**ADDRESS: 801 EDISON**

**APPLICATION NO: HDC2025-00037**

**SCOPE: REPLACE WINDOWS, GUTTERS, AND DOWNSPOUTS**

### House

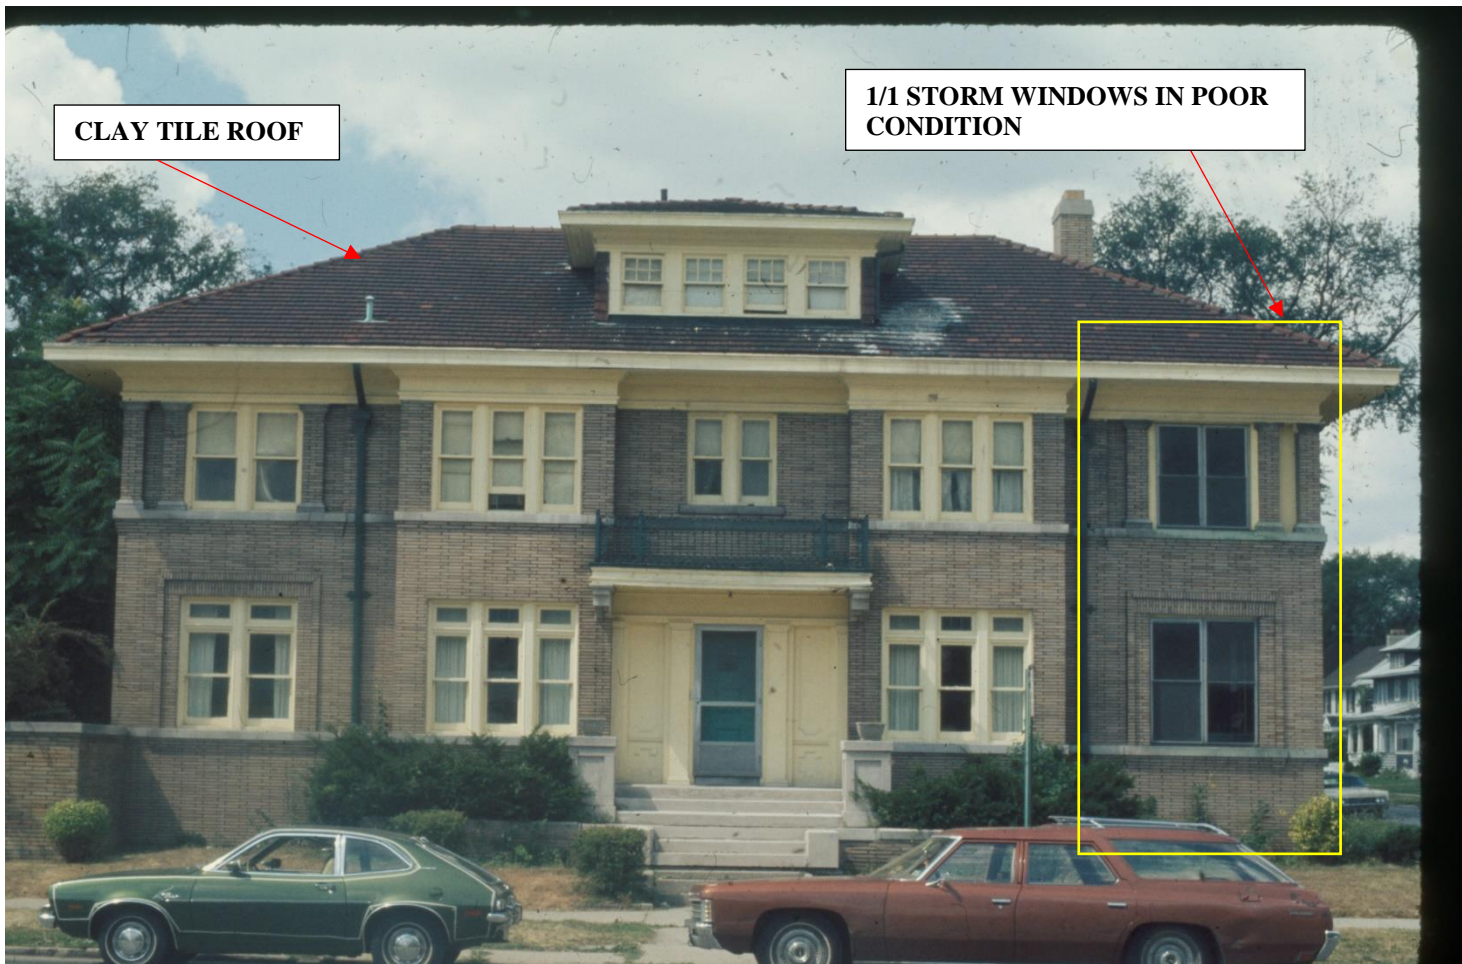
- The application proposes to shingle over the historic built-in gutters and install new k-style, aluminum hanging gutters at the roof's fascia. Staff notes that the roof's deep, overhanging eaves with its flat, unadorned fascia are a distinctive, character-defining feature of the house. The addition of hanging, k-style gutters to the fascia will alter the appearance of the house's eaves and therefore will detract from the building's historic character. It is staff's opinion that this scope item does not meet the Standards for this reason.

- Element of Design #7 *Relationship of materials*, states that "wood is almost universally used for window frames and other functional trim and is used in many examples for all trim." The shingling over of the historic built-in gutters and installation of hanging gutters would introduce an incompatible metal element which would obscure the roof's character-defining wood trim elements/fascia and eaves, which does not conform to Element of Design #7

- Element #10 *Relationship of architectural details*, states that "in general, the various styles are rich in architectural details." Note that the building's deep, overhanging wood eaves are characteristic of the Prairie style and the built-in gutters are an architectural detail which allow for a clean expression of the building's character-defining eaves/fascia. As noted previously, the addition of hanging gutters would alter the appearance/geometry of the character-defining eaves, which does not conform to Element of Design #10

#### **Recommendation 1 of 2, Denial: Replace internal gutter system at the house with new aluminum, k-style hanging gutters**

- The roof's deep, overhanging eaves with its flat, unadorned fascia are a distinctive, character-defining feature of the house. The addition of hanging, k-style gutters to the fascia will alter the appearance of the house's eaves and therefore will detract from the building's historic character.

801 Edison, photo taken in 1980. See the side porch wing. The windows at the porch outlined in green are jalousie windows. All other windows at the porch appear to be 1/1 storm windows

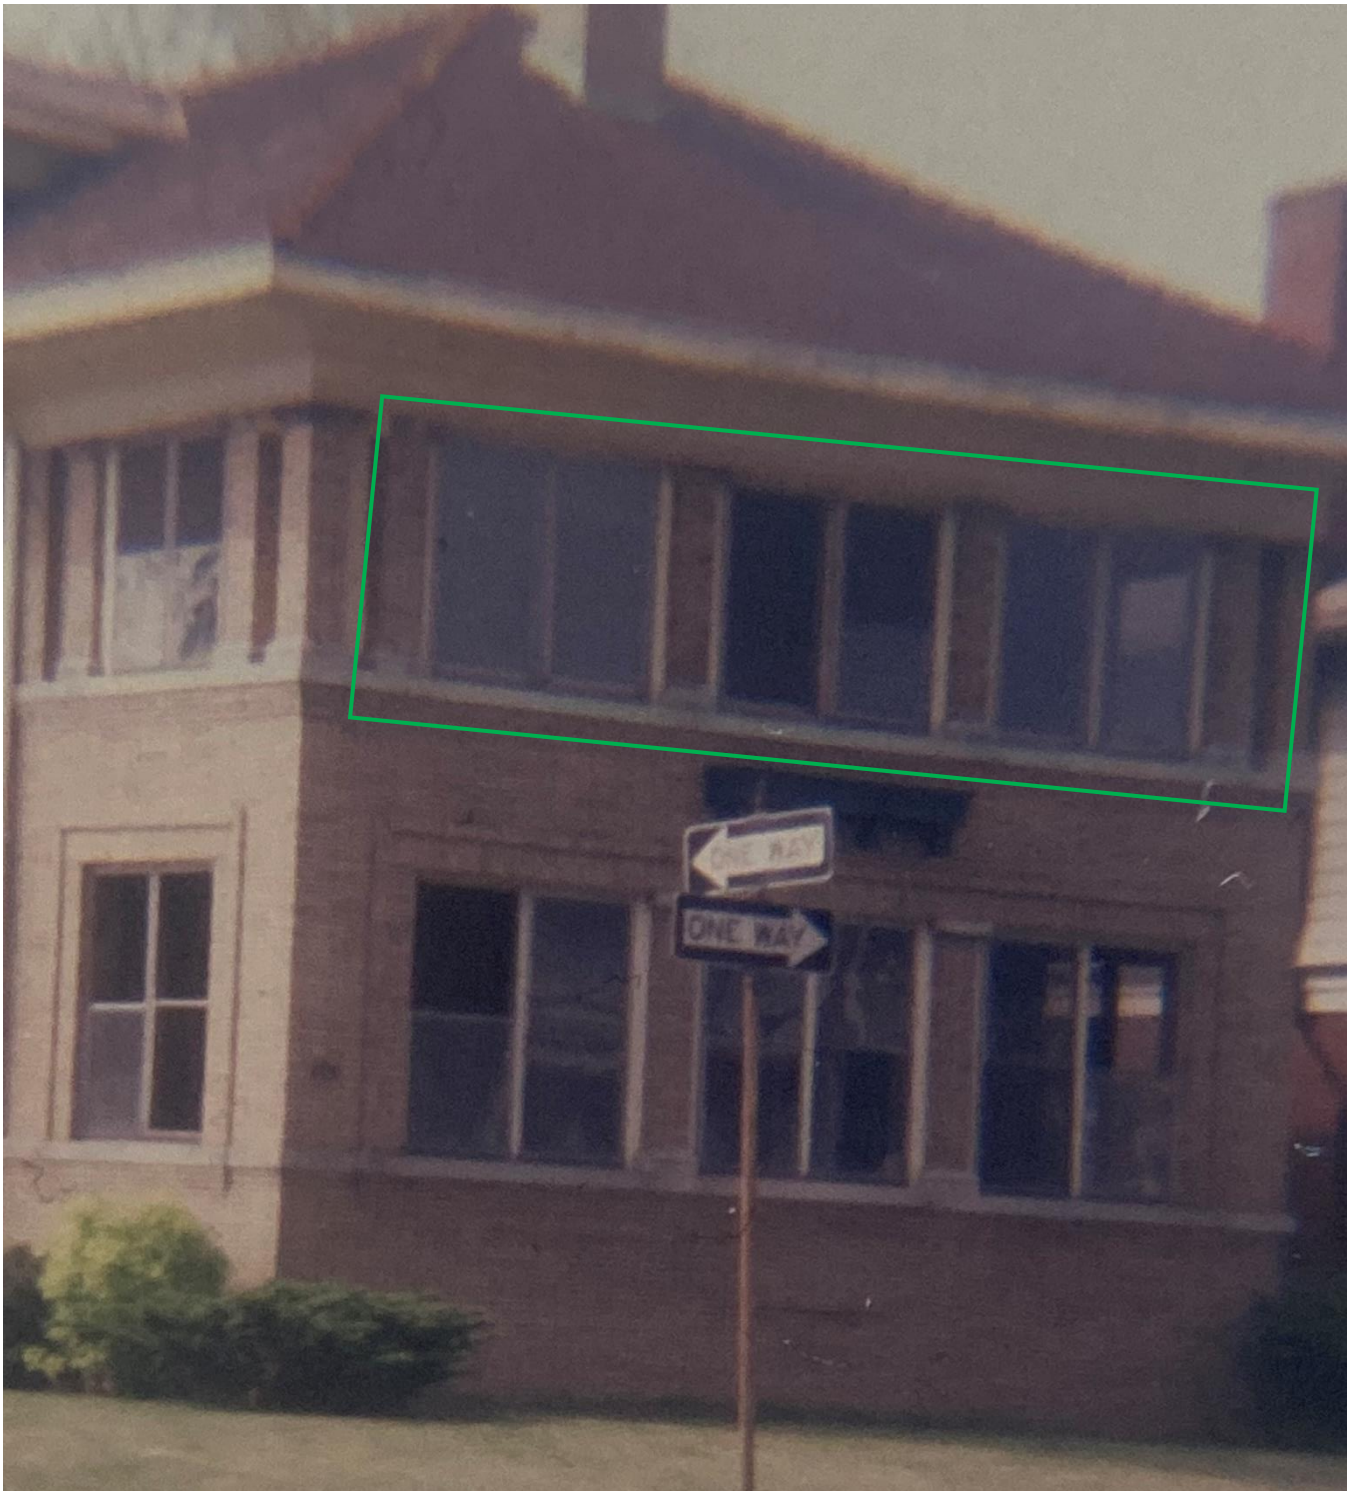
- It is staff's opinion that the windows that were present at the side porch at the time of the district's designation were not original to the property's date of construction. Specifically, the porch was likely open when the house was built, and the jalousie and storm windows were likely installed post 1950s. Also, in 1974, the storm windows at the side porch appeared to be in poor condition. It is therefore staff's opinion that the windows present at the porch in 1974, at the time of the district's designation, were not distinctive character-defining elements of the house.

East/front façade, showing windows at porch which are proposed for replacement. Staff photo taken on 2/25/2025

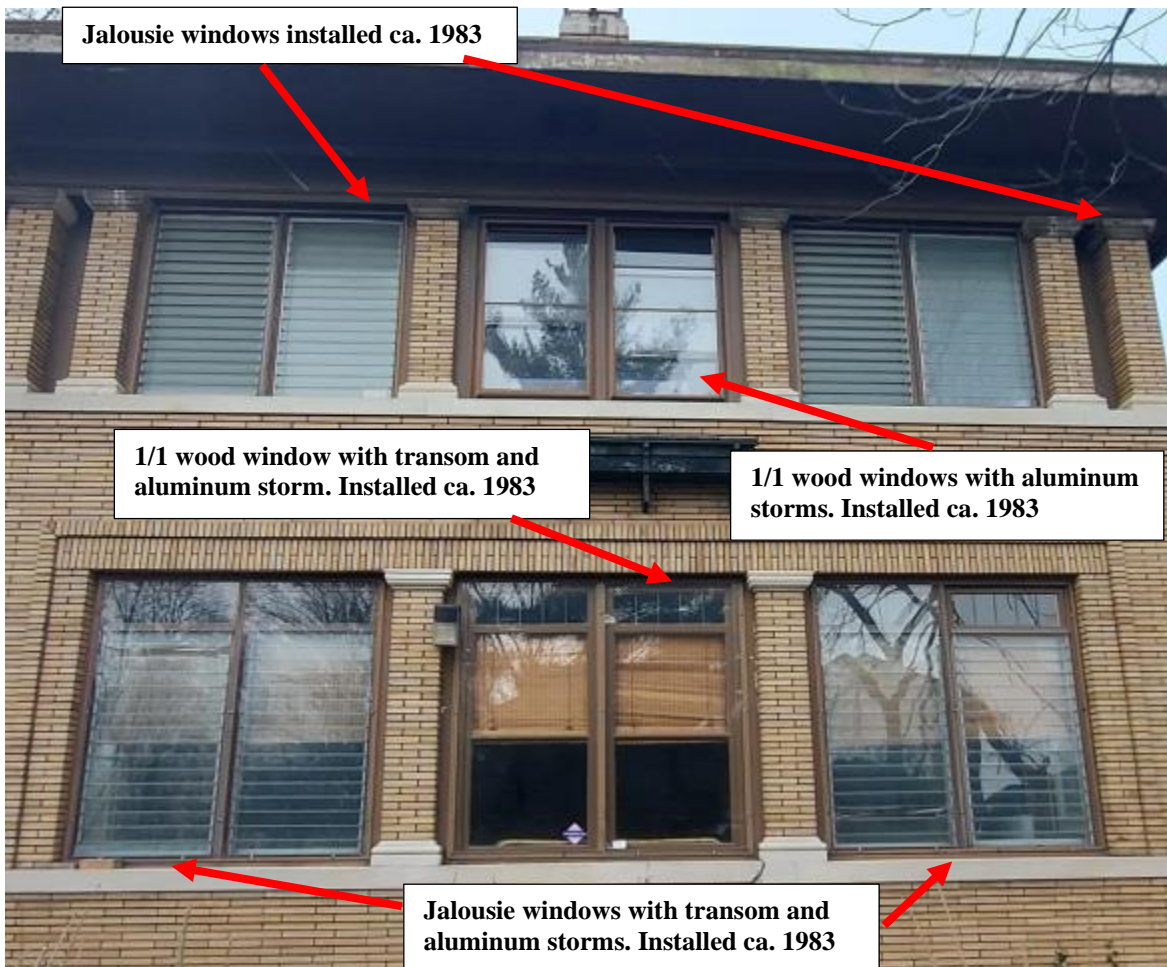
- See the below photos of the windows at the side two-story porch. A review of HDC records indicated that the current porch windows were likely installed in 1983. Note that the windows at the first story are 1/1 wood units and jalousie units. Each window at the first story is topped with a fixed transom with metal casing, consistent with the original wood windows at the house's main body, first floor. The porch's second story windows are 1/1 wood units and jalousie windows without transoms, which is consistent with the original wood windows at the house's main body, second floor. Aluminum storm windows, also added ca. 1983, are present at all of the porch windows with the exception of two jalousie windows at the porch's south façade, second story. Staff was unable to locate a COA for the existing wood porch windows. However, as noted above, the porch windows which were present in 1974/at the time of the district's designation which were replaced by the current windows were not original to the building's construction and were not character defining. Their removal in 1983 was therefore appropriate. However, staff would have recommended that any new windows proposed for installation at the side porch be simple 1/1 wood units with minimal casing/trim of a simple profile and clear/transparent, non-reflective glass as the openings at the porch would have originally been open/unenclosed. Staff therefore would have recommended against any proposal that the new windows include a transom.

- Staff supports the proposed removal of the existing porch windows as they are not historic-age, distinctive character defining features of the house.

- The windows will have black screens which, when combined with the proposed black frames, will detract from the porch's original open character. Staff recommends that a less opaque screen be selected for this application

- The windows which include transoms will detract from the porch's original open character. Staff recommends that all of the windows have a simple 1/1 light configuration.

- The new porch windows shall not have black screens. A less opaque screen type/color shall be selected and submitted to staff for review and approval
- The new porch windows shall not include transoms. Rather, they shall have a simple 1/1 light configuration
- The windows at both the house's main body and two-story porch shall be one uniform color. Therefore:
  - The new porch windows shall be finished with brown color to match the color of the windows and storms at the house's main body
